- Statement of Direction (SOD) for Major
 Special Use Permit (SUP) amendment for
 Lincoln Medical Plaza at 7125 E Lincoln Drive
 - SOD Action (Tentative) June 14th
- Points to keep in mind
 - Several aspects of project do not meet SUP Guidelines and/or may be in conflict with General Plan policies
 - Height, traffic and circulation, and depth of the perimeter landscape buffers are of particular concern
 - Many application submittal items are not fully complete, but do provide the nature of the proposed redevelopment

COMPONENTS - PROPOSED MAJOR SUP AMENDMENT

SITE PLAN

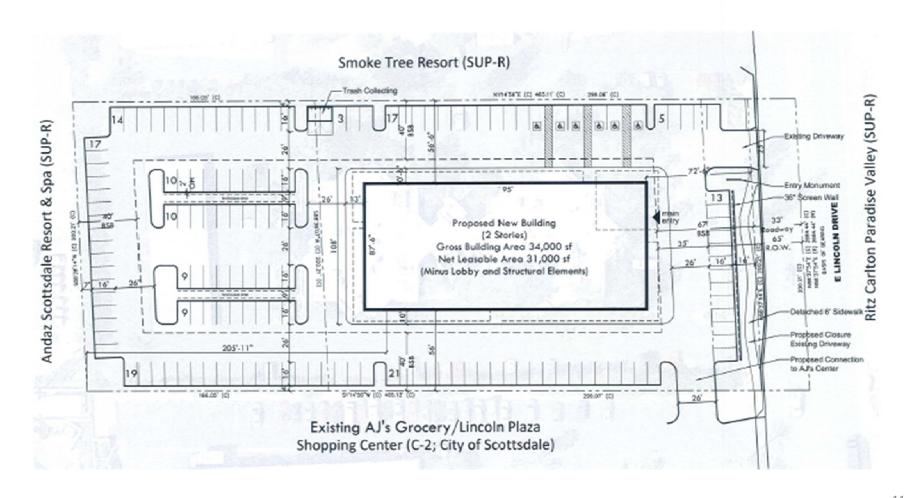
■ Two-story, 36' high structure

■ 18.7% lot coverage

■ 37% FAR

Setbacks

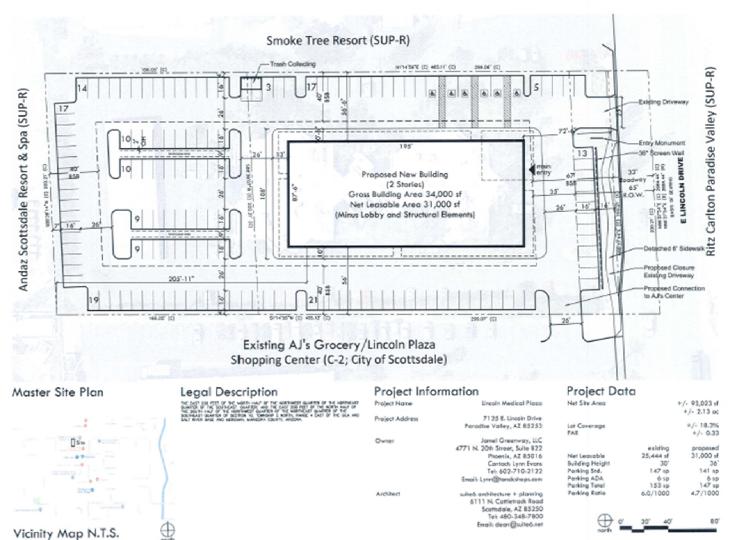
Topic	Town Code/Special Use Permit Guideline/Town Policy Existing Condition	
Setbacks	This site is unique in that the adjoining properties are all non-residential. As such, the only Special Use Permit Guideline that applies on setback is the suggested 40' setback from a public street.	The proposed setbacks of 67' front yard (35' with full right-of-way dedication), 56' side yards, and 185' rear yard is consistent with Town Special Use Permit Guidelines
	The existing structure is setback 94' from Lincoln Dr (62' with full right-of-way dedication).	Applicant will need to provide plans for the proposed covered parking.
	The existing covered parking is south of the existing building, setback well beyond 40' from Lincoln Dr.	Setbacks meet SUP Guidelines but may need to be increased along Lincoln Drive to accommodate the recommended 50-foot wide landscape buffer adjoining a major arterial. If covered parking is provided, setbacks from these structures will also need to be reviewed.

Buffering

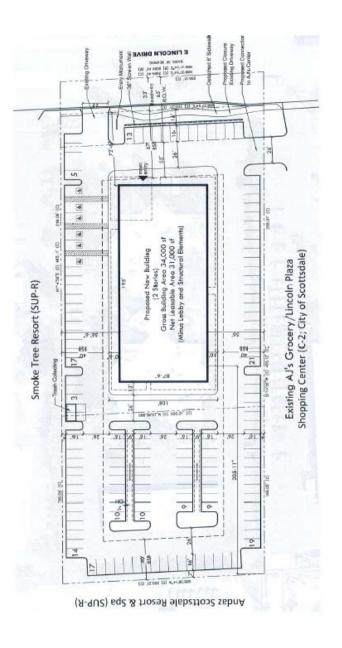
Торіс	Town Code/Special Use Permit Guideline/Town Policy Existing Condition	Proposal by Applicant Suggested SOD Focus
Landscape/ Buffering	50' buffer along major roads (SUP	16' and 30' along Lincoln Dr (includes portion of future right-of-way) 4' buffer on sides and 7' buffer in rear Based on the proposed building design, the large trees in the center of the site will be removed Particular attention shall be paid to the buffer along
	Existing buffers 34' Lincoln Dr (16' in existing ROW) 3'6" sides and rear yard Existing tall hedges and 3' to 6' tall block wall act as perimeter buffers	Lincoln Drive based on the proposed Visually Significant Corridor study and the improvements proposed at the Ritz property just to the north. A stipulation may be considered to ensure replacement of any buffer should the landscaping die. A landscape plan shall be required. The Commission shall evaluate the proper balance of landscaping to soften the building while not obscuring it from the street. Hardscaping and pedestrian access shall be considered with the landscape plan.
